# ADDENDUM NO. 3

Rochester City School District

Dr. Walter Cooper, School #10

March 7<sup>th</sup>, 2018

**6** INTERIOR FOUNDATION WALL AT STAGE/PLATFORM  
3/4" = 1'-0"

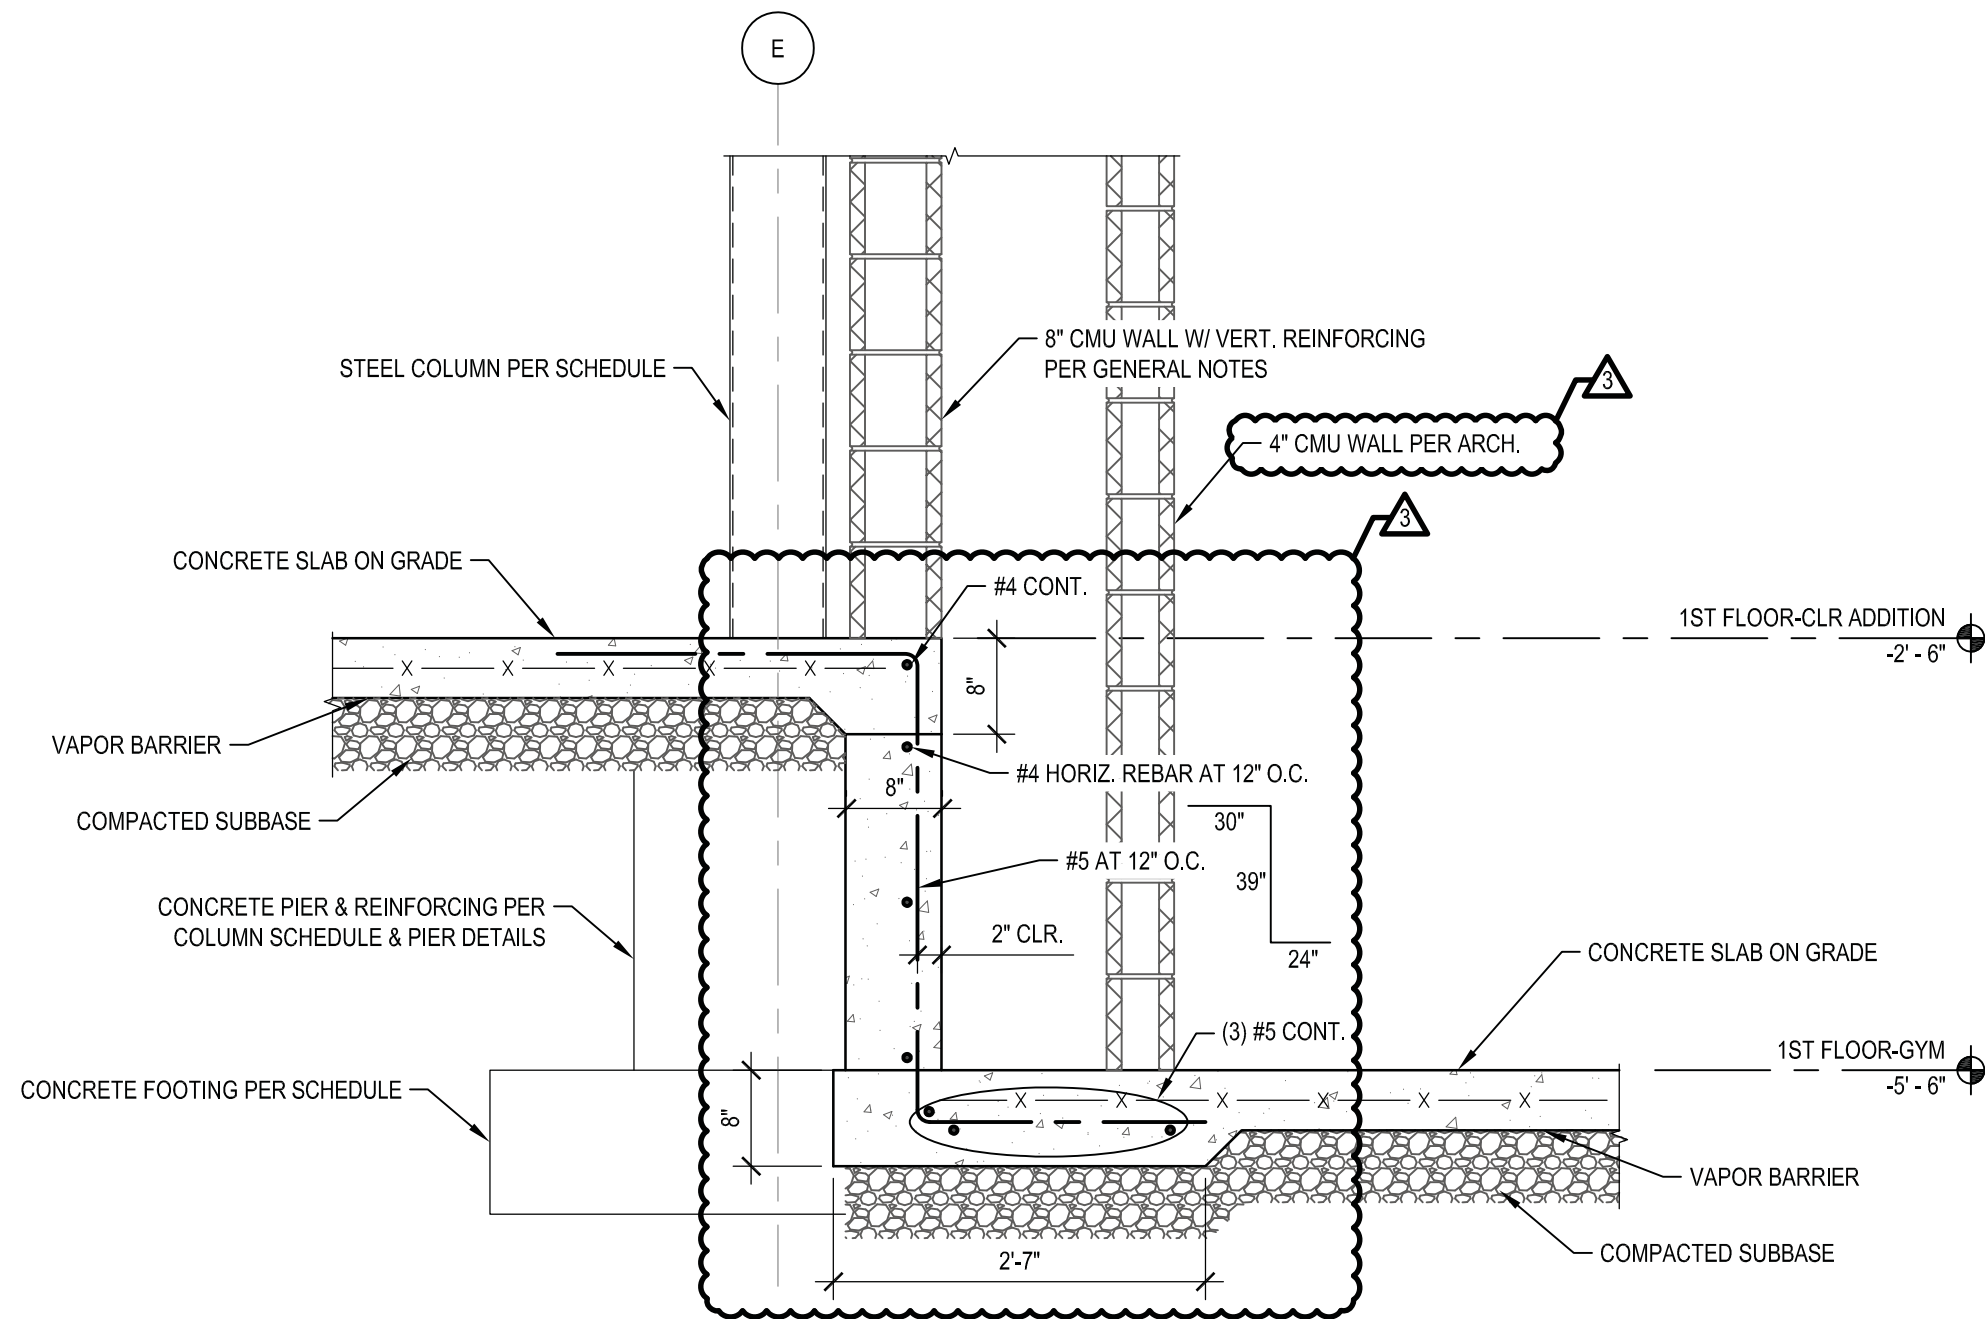
Item AD3-75 **REPLACE** Detail 6 with attached sketch "AD3-S016 - INTERIOR FOUNDATION WALL AT STAGE/PLATFORM"  
Item AD3-76 **REPLACE** Detail 7 with attached sketch "AD3-S017 - TYPICAL EXTERIOR WALL FOUNDATION"

**7 FRAMING OF BALCONY STORAGE AREA**  
3/4" = 1'-0"

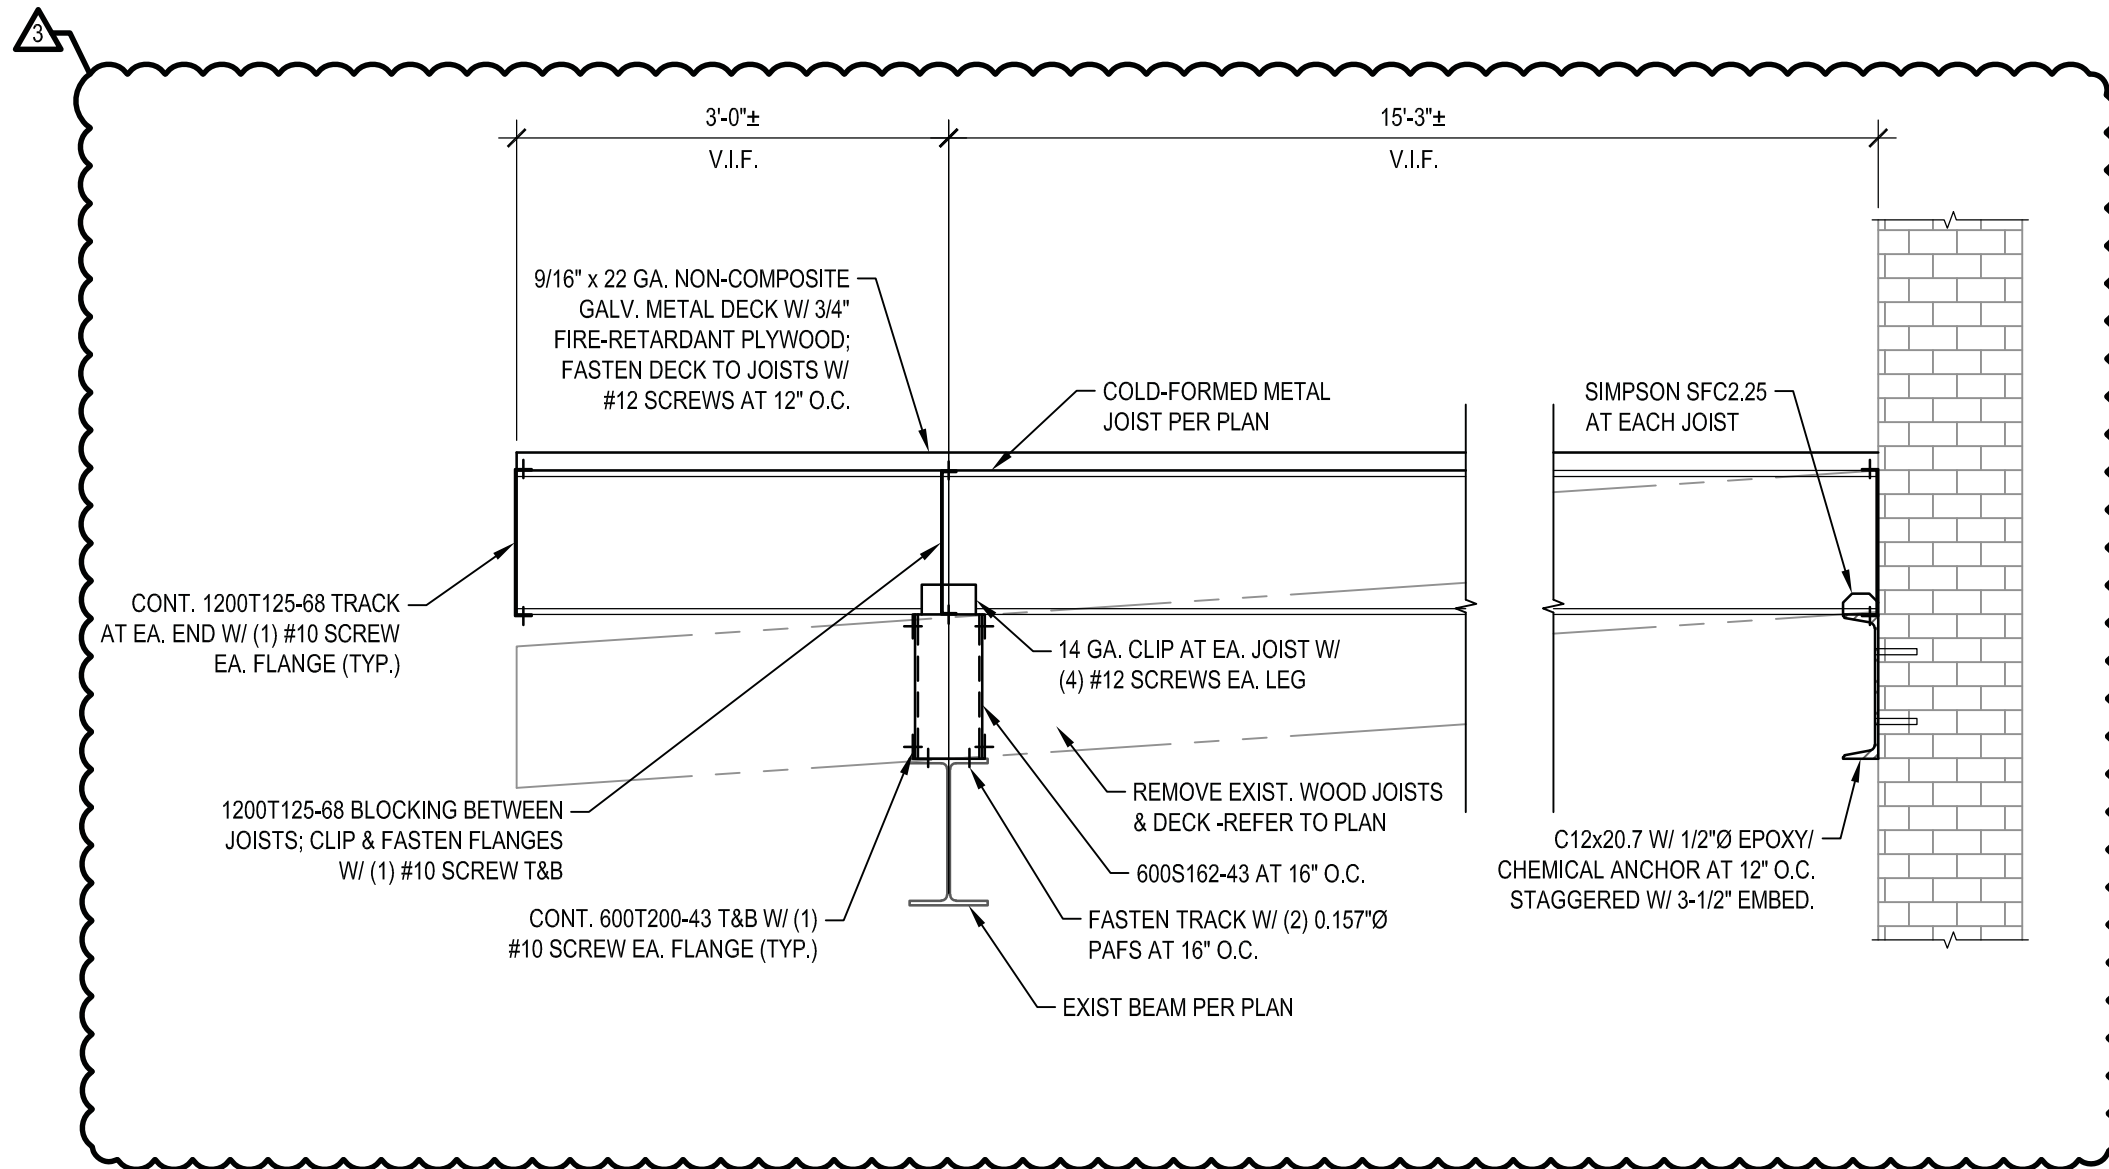
Item AD3-80 **ADD** dimension between the grid line and the edge of deck of “10 3/8” to Detail 4.  
 Item AD3-81 **REPLACE** Detail 7 with attached sketch “AD3-S018 – FRAMING OF BALCONY STORAGE AREA”  
 Item AD3-82 **ADD** callout “TYP. FRAMED BEAM TO HSS COLUMN CONN.” to Detail 8.

**AD3-S019**

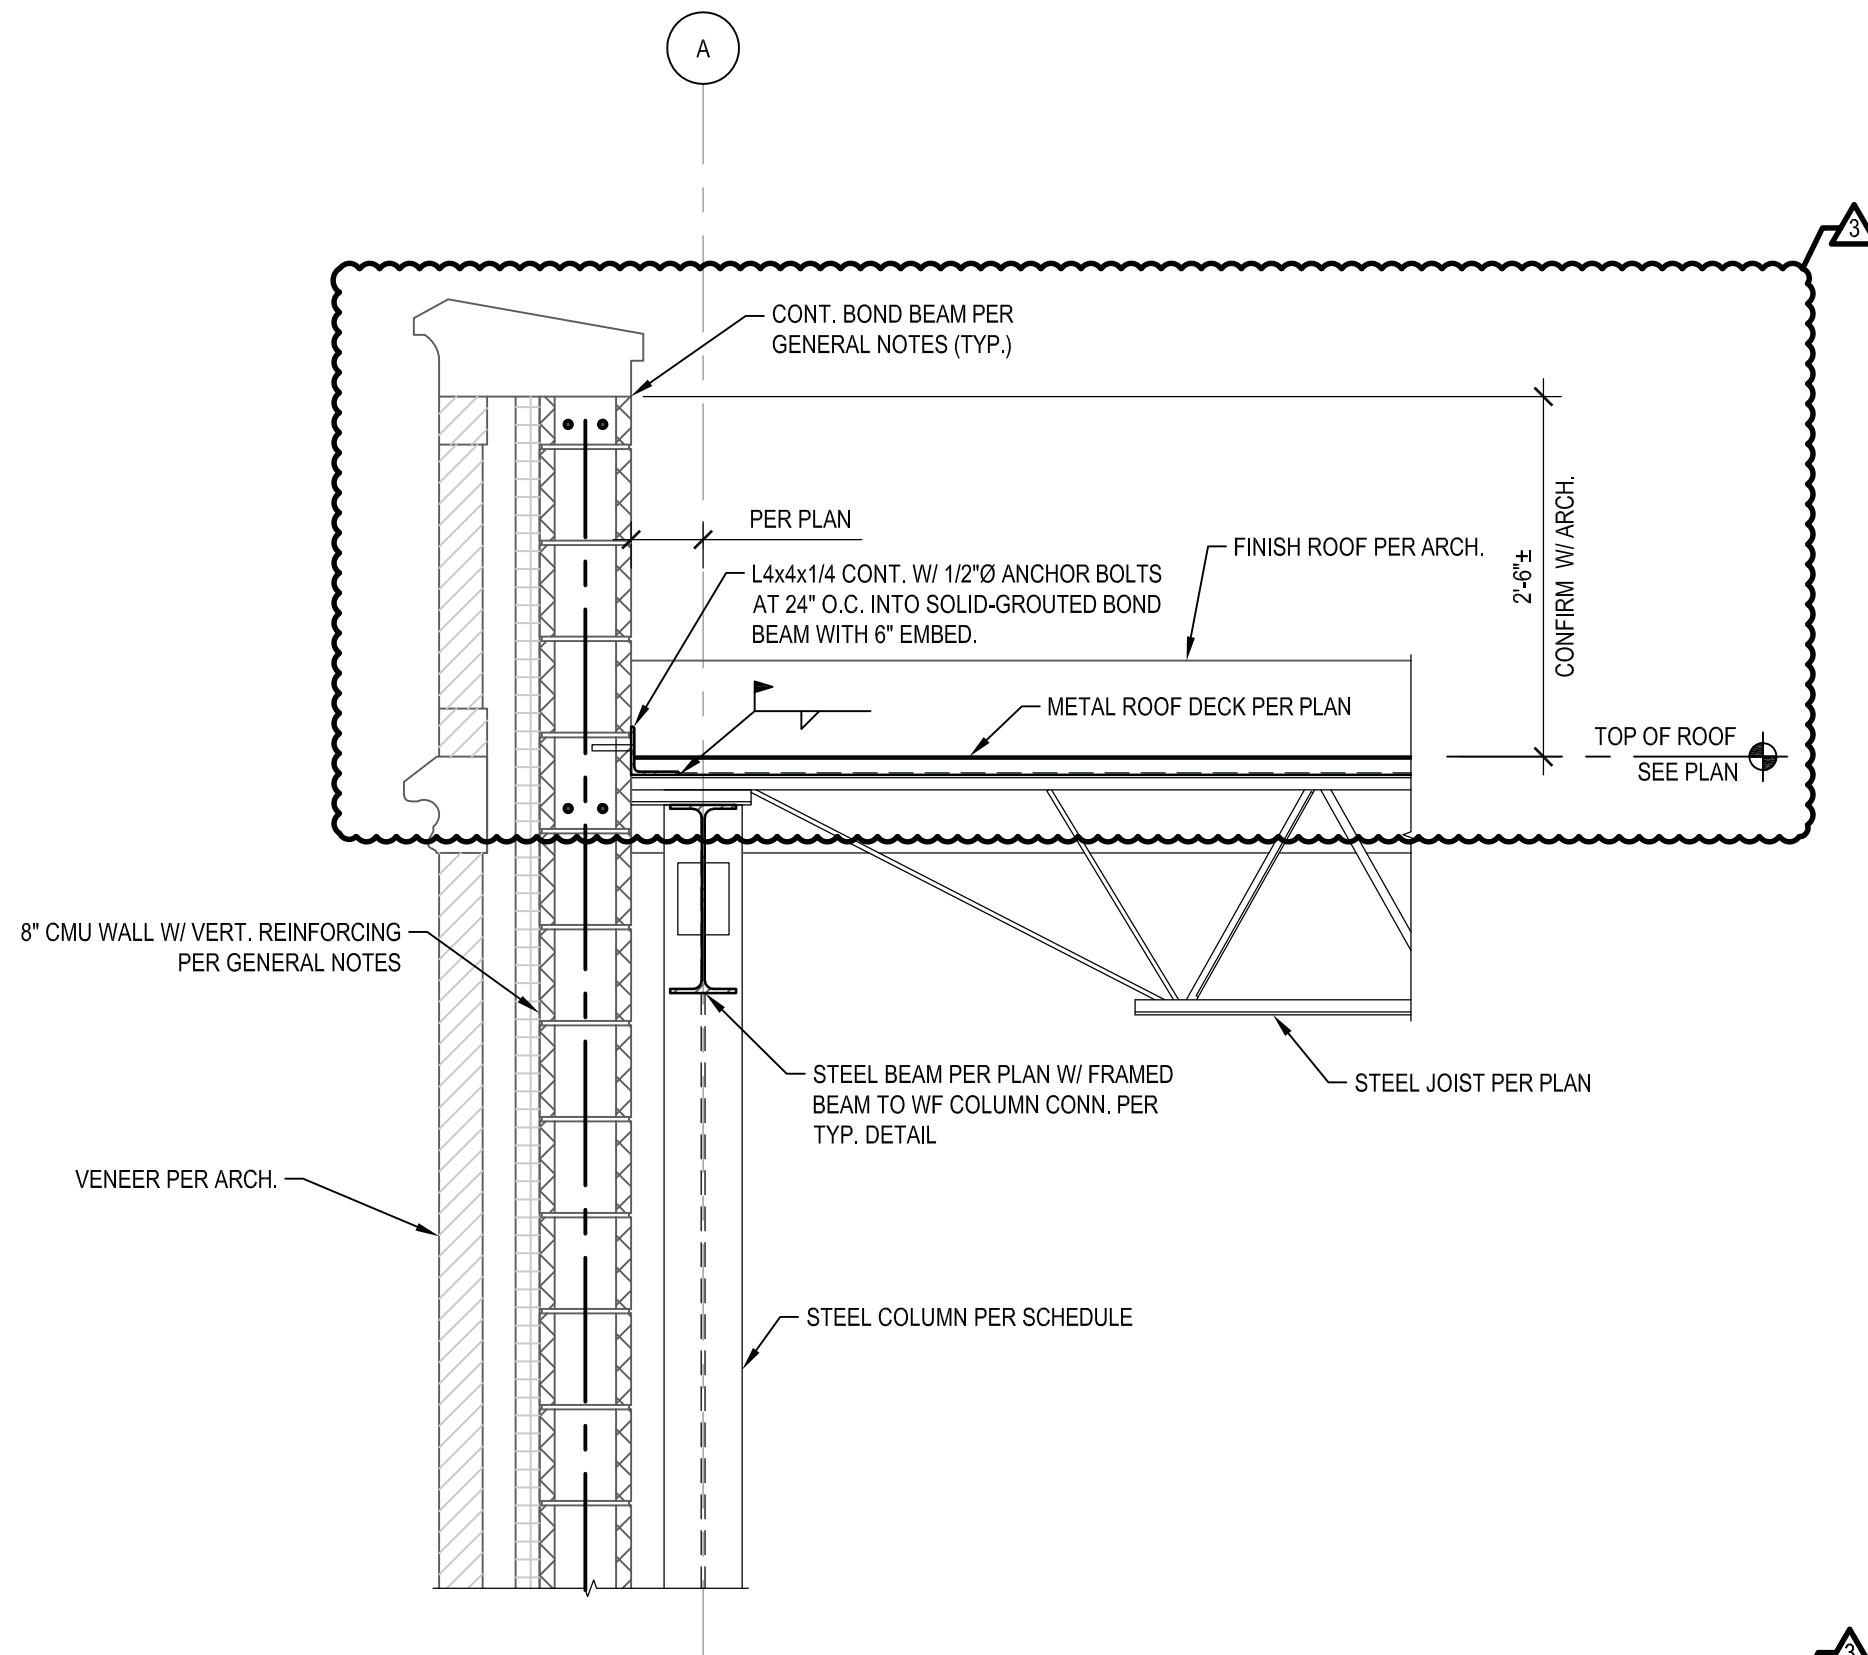
Item AD3-83 **ADD** callout “TYP. FRAMED BEAM TO HSS COLUMN CONN.” to Detail 8.  
 Item AD3-84 **REPLACE** Detail 6 with attached sketch “AD3-S019 – STEEL JOIST AT EXTERIOR CMU WALL”

**AD3-A001**

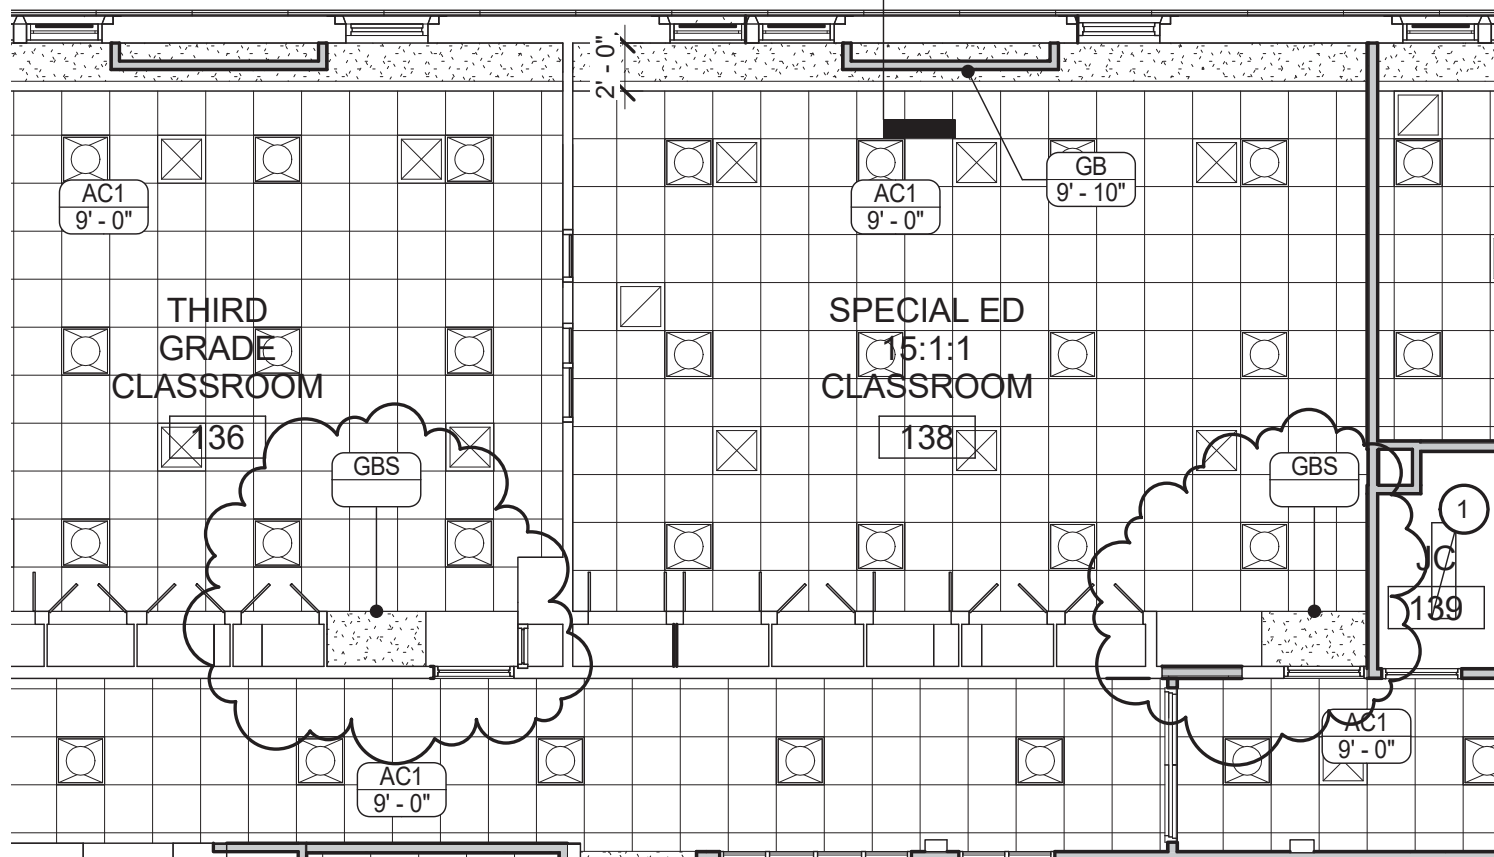
Item AD3-97 **ADD** attached sketch “AD3-A001 – REVISED RCP AT CLASSROOM 136 & 138.” Added soffit at classroom entrance
